March 4, 2019

Re: SUP 18-06 / Major Amendment for Lincoln Plaza Medical Center / 7125 E. Lincoln Drive.

**TAB 4**

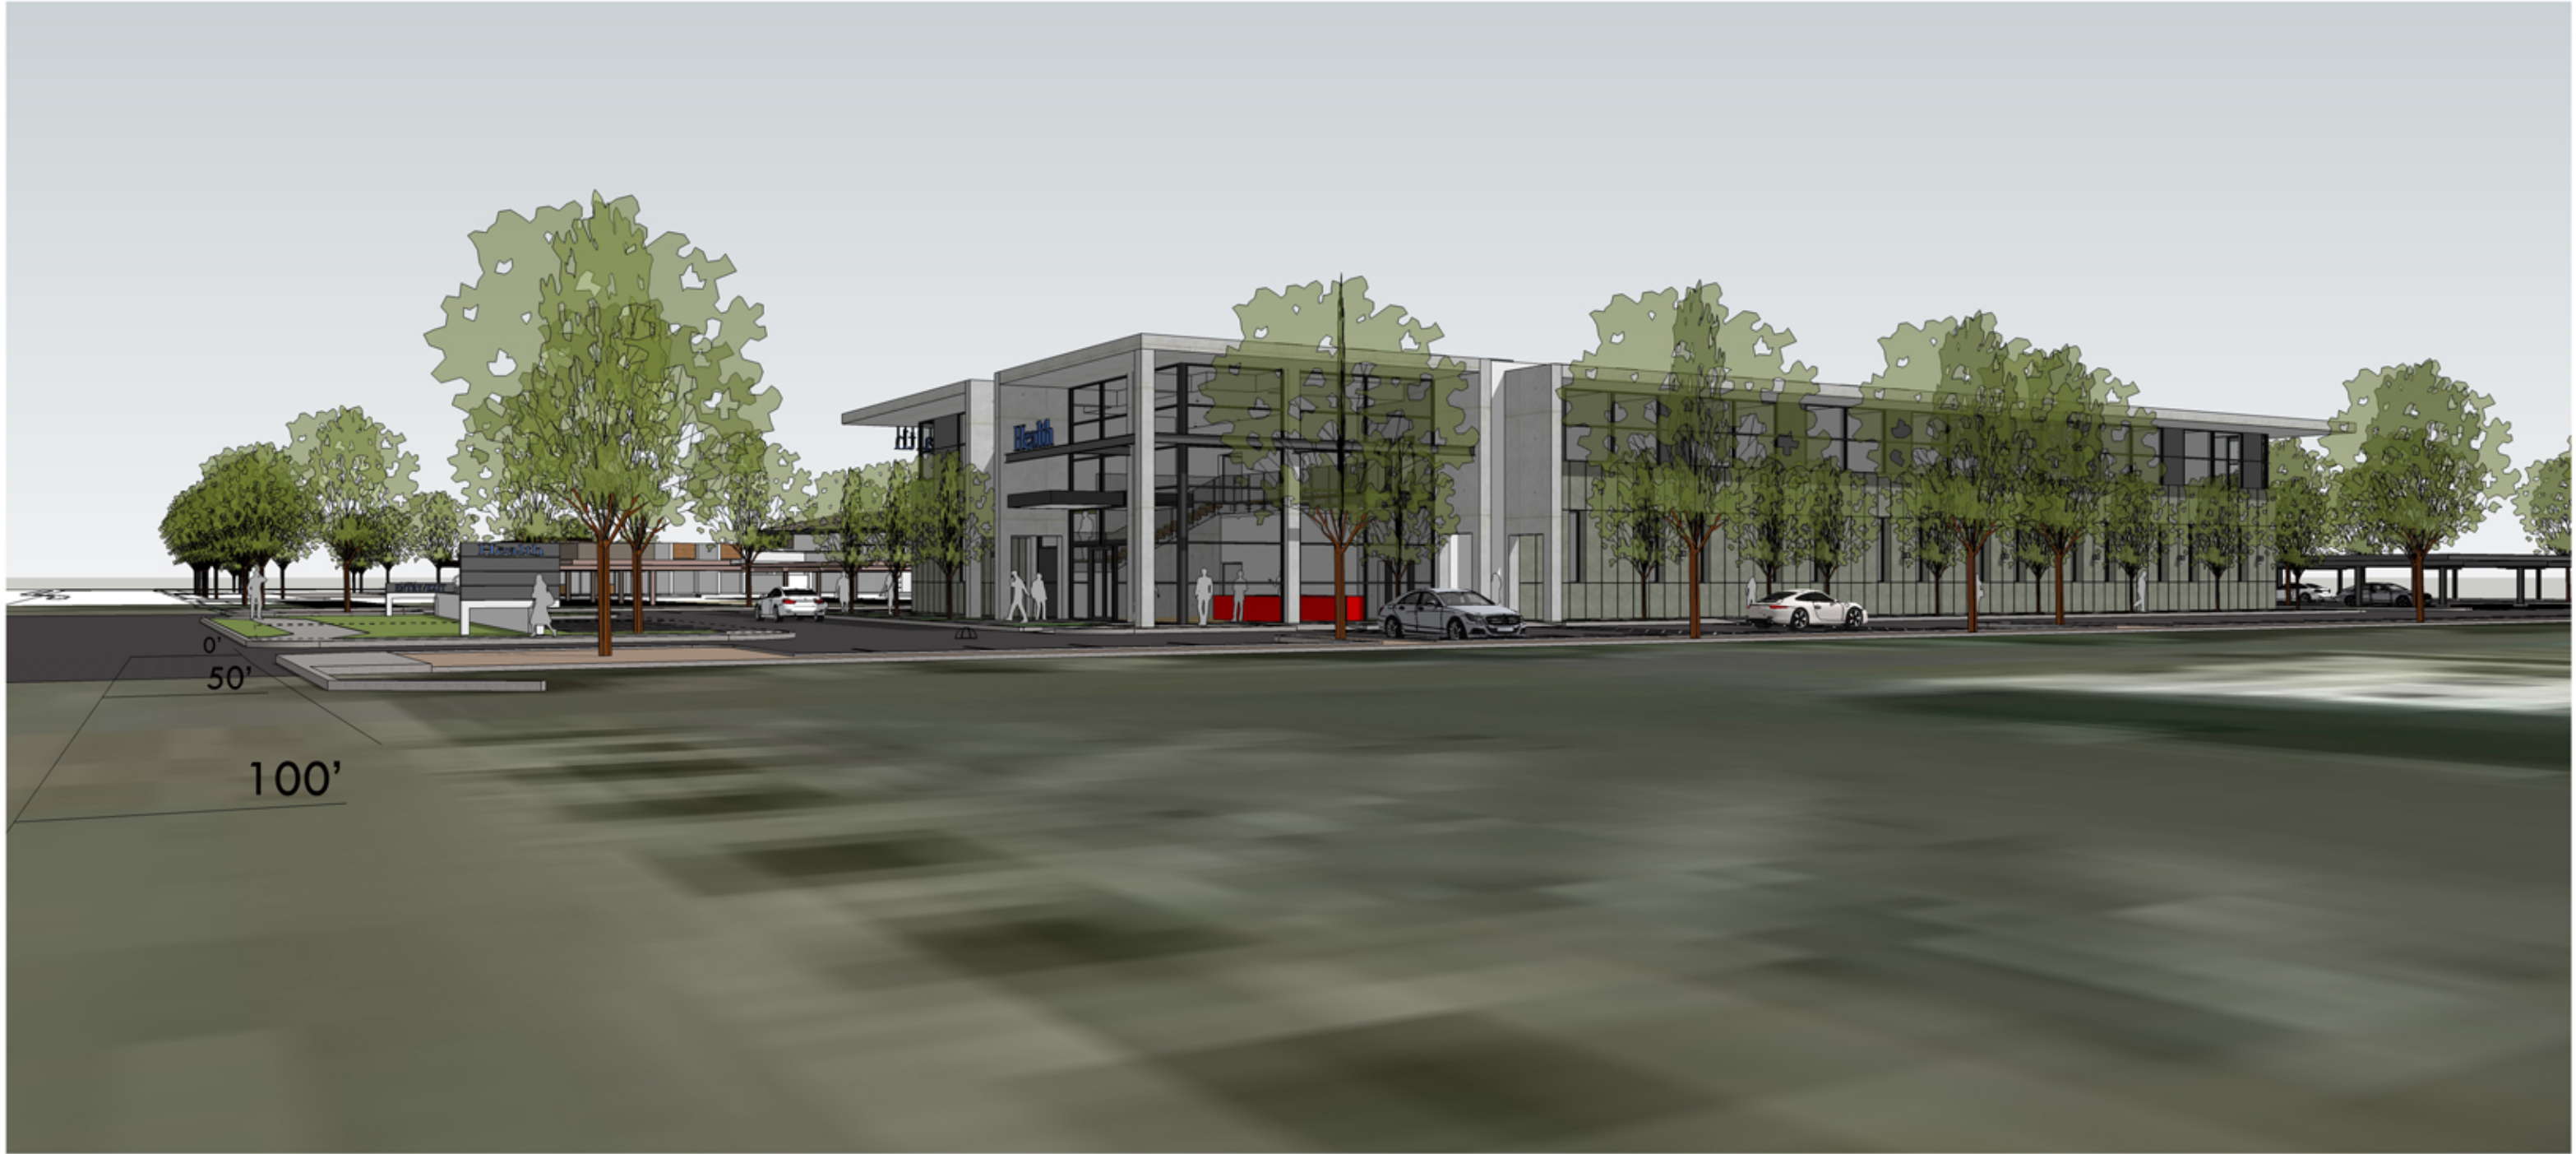
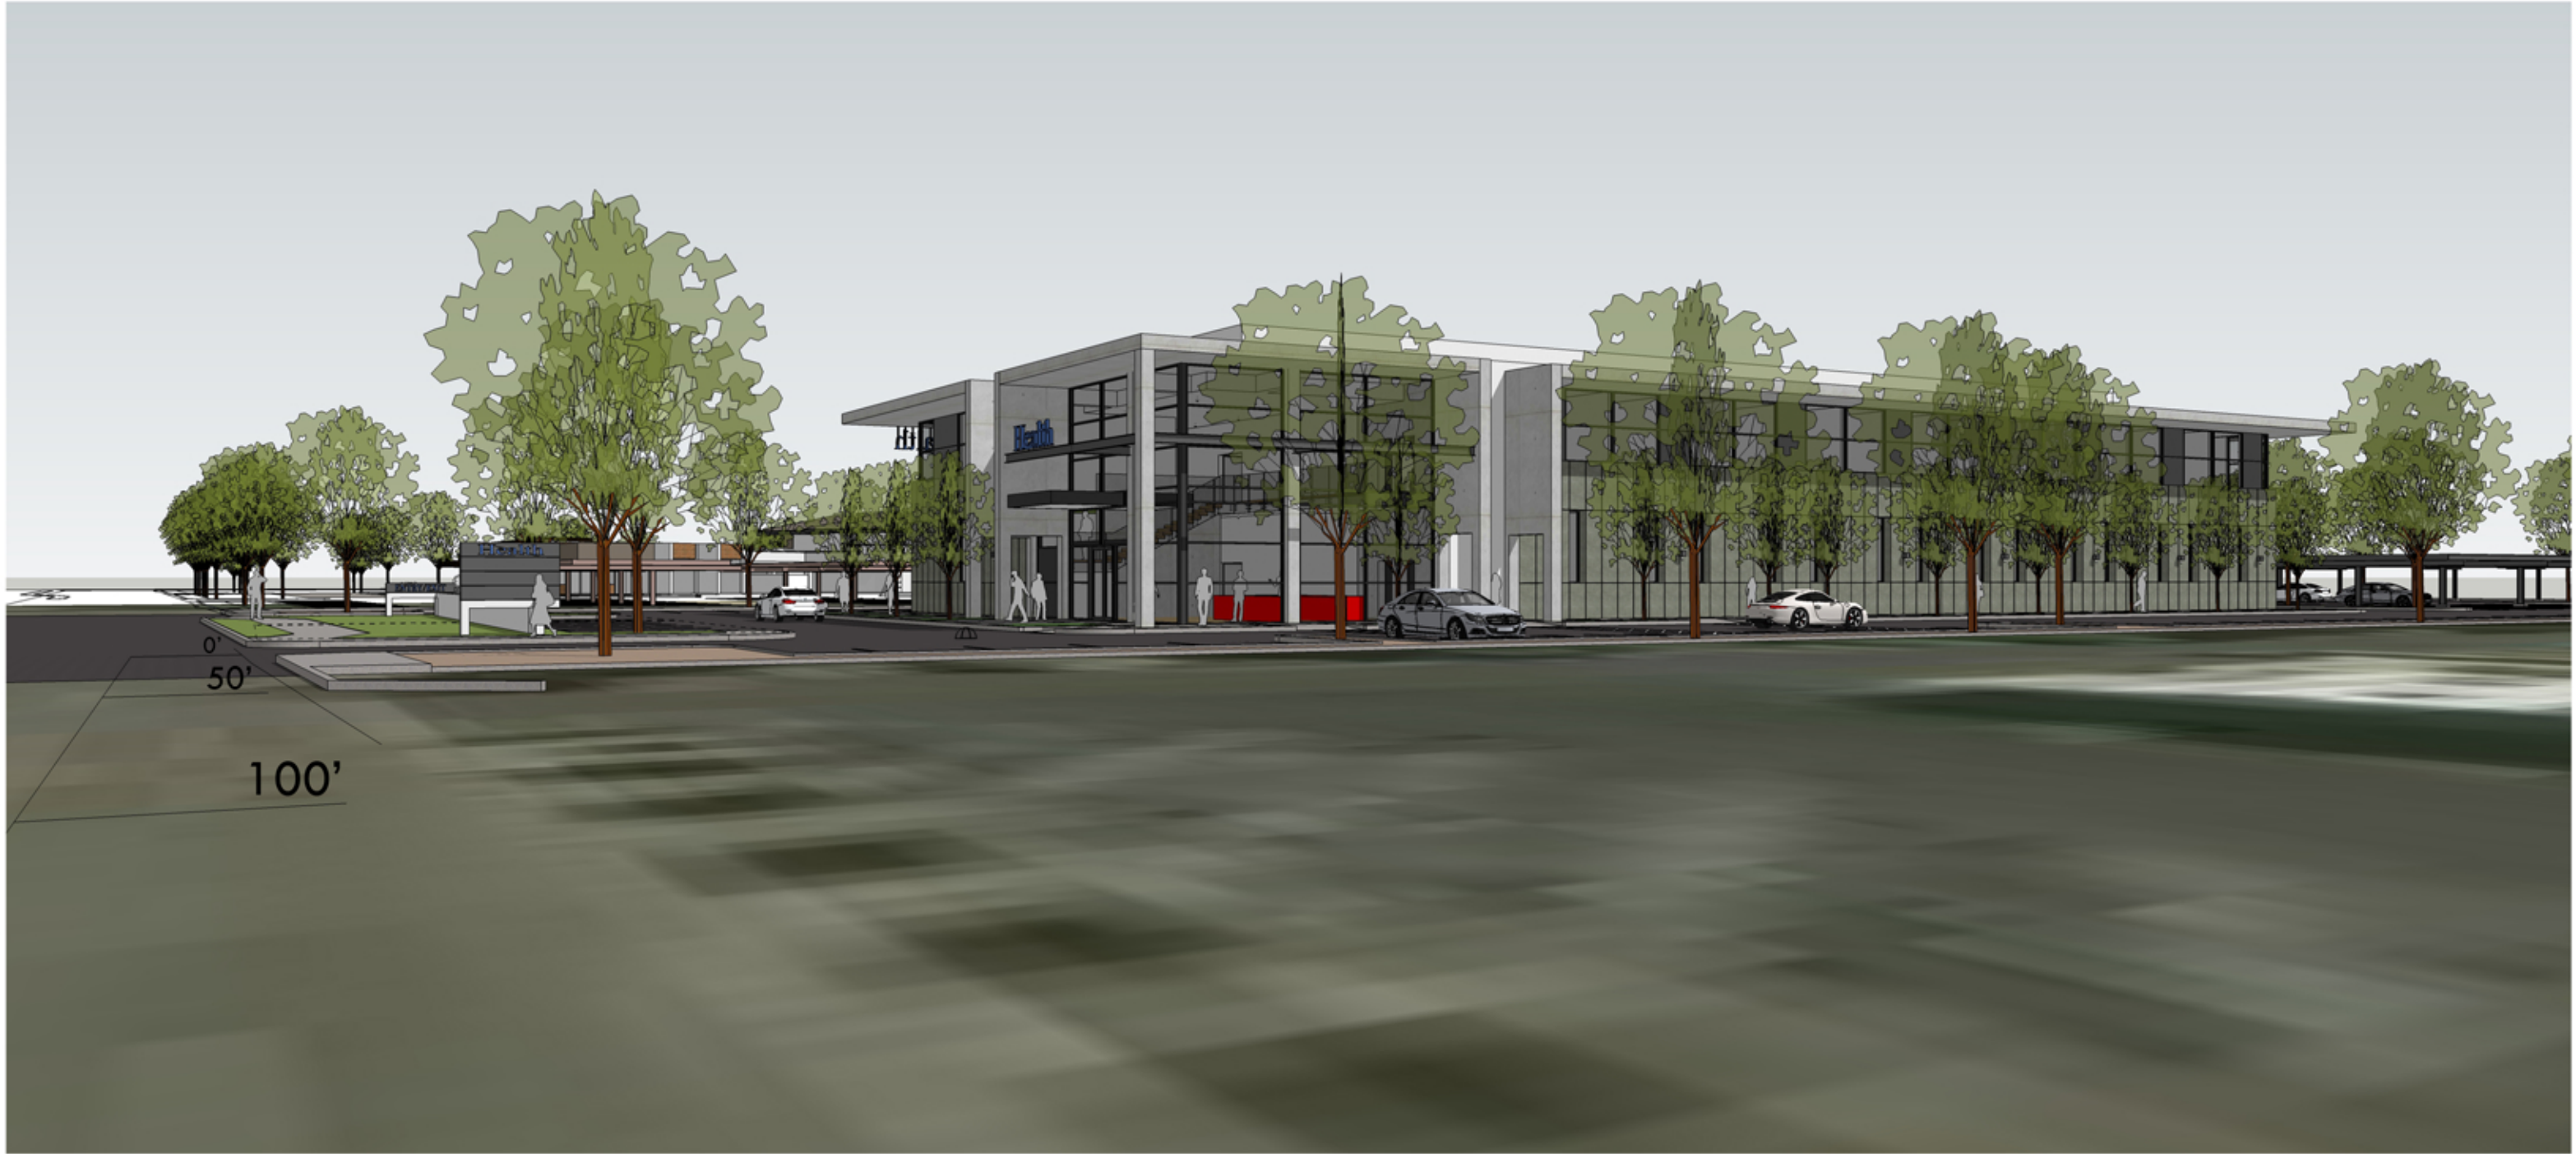
As the attached exhibits demonstrate, the additional height created by the screen wall is barely visible even at a distance of 200 feet from the Property and has no negative visual impact whatsoever. See Rooftop Screen Exhibits at **Tab 4**. The setback of the mechanical equipment from the edge of the roofline is so significant that the roof itself screens the mechanical equipment.

Photometric Site Plan

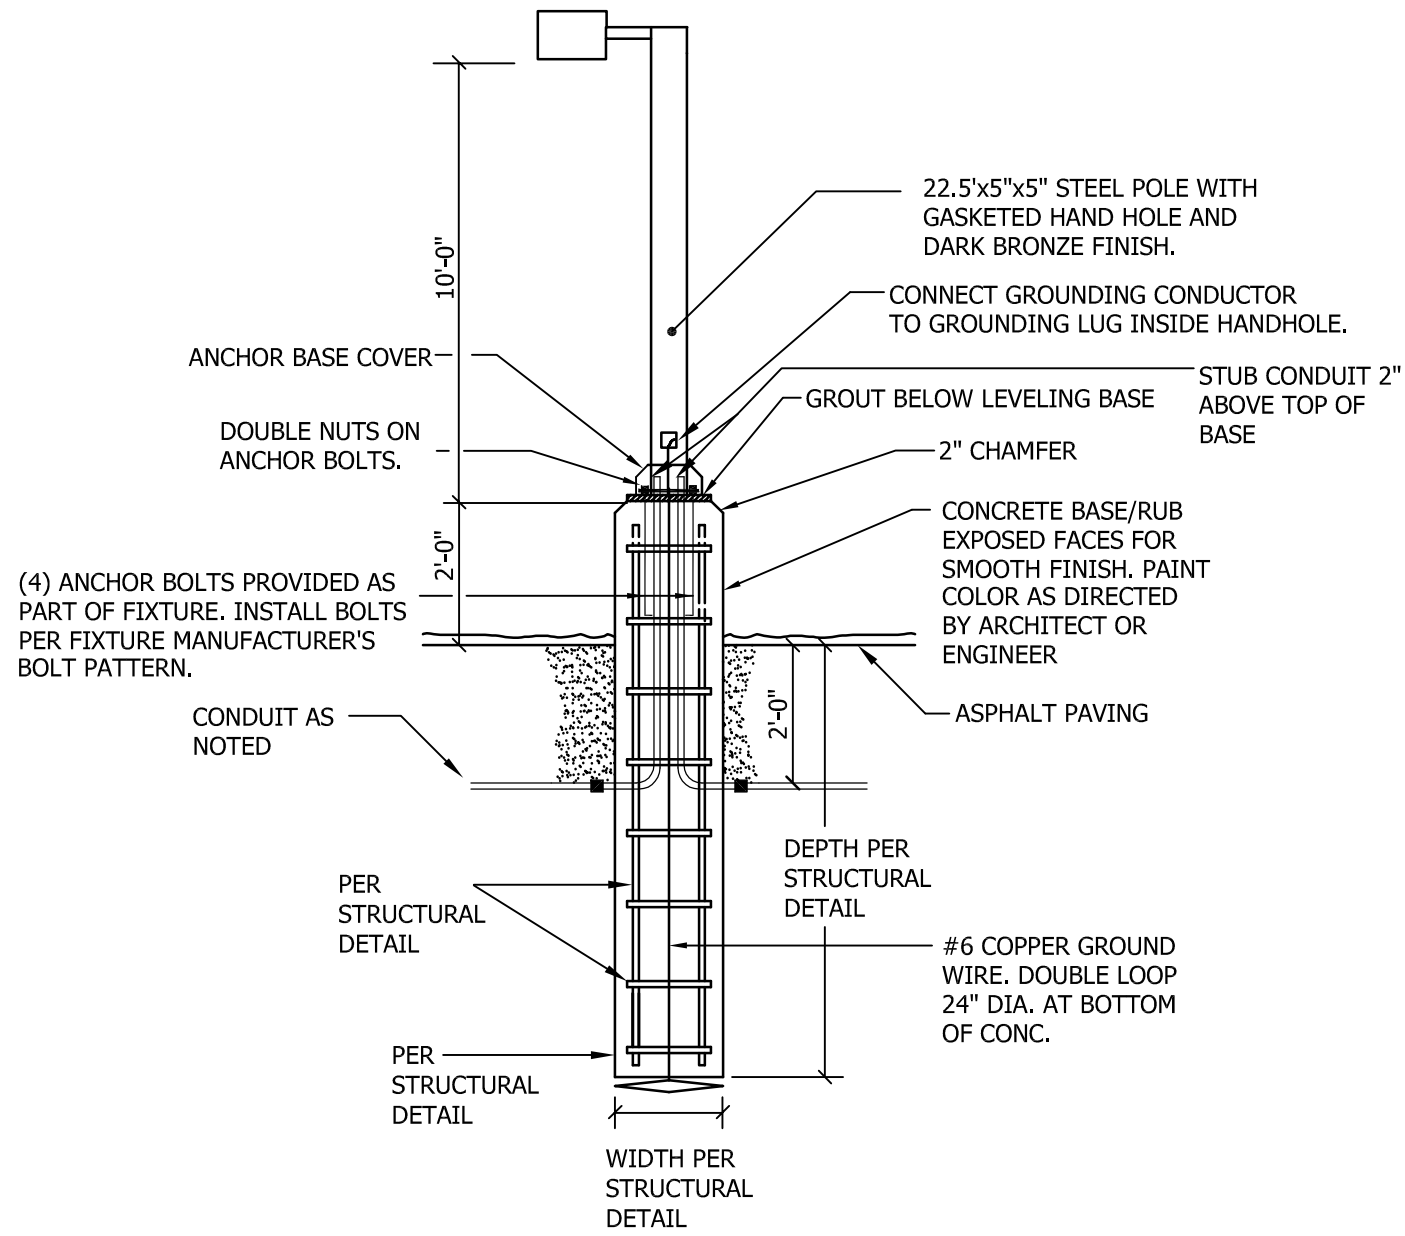
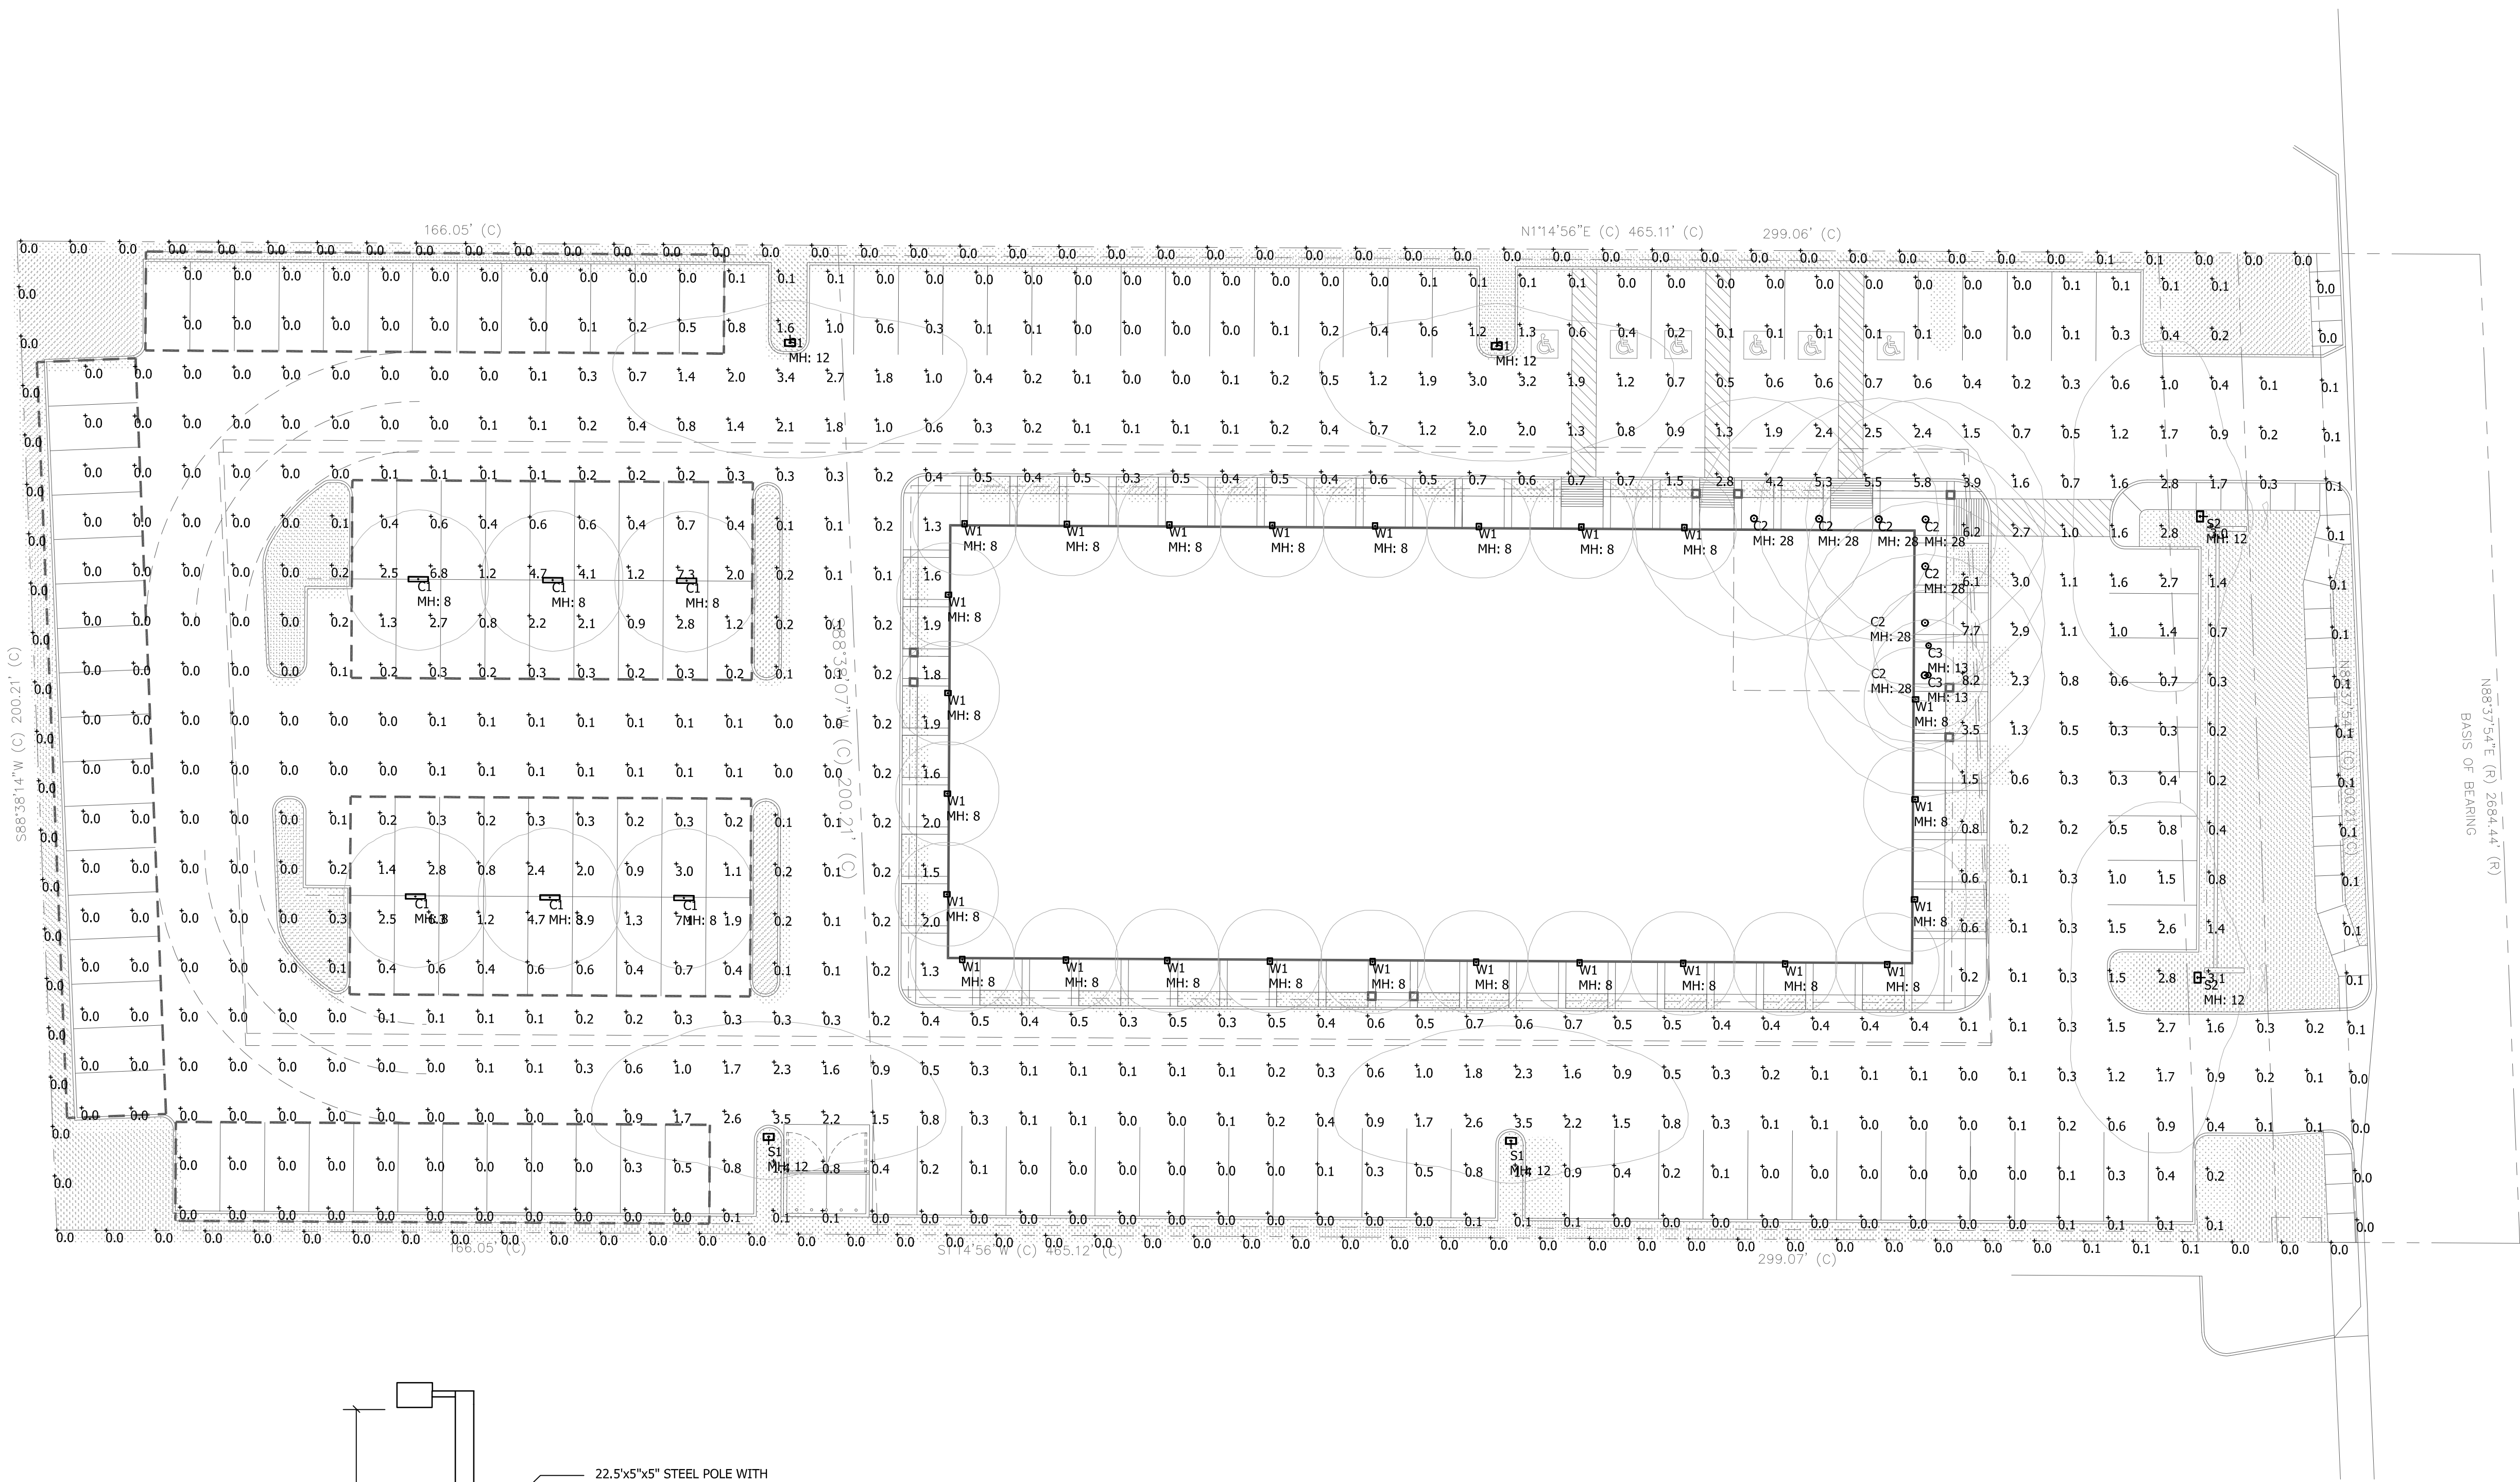
Staff also noted concern expressed by a councilmember related to the ambient light emitted by the building at nighttime. These concerns were previously addressed by the photometric exhibit submitted by the applicant, as well as the lighting-related stipulations in the draft SUP ordinance unanimously recommended for approval by the Planning Commission. The photometric exhibit attached at **Tab 13** shows that illumination at the property line is between 0.0 and 0.1 foot-candles – a negligible to non-existent level of ambient light.
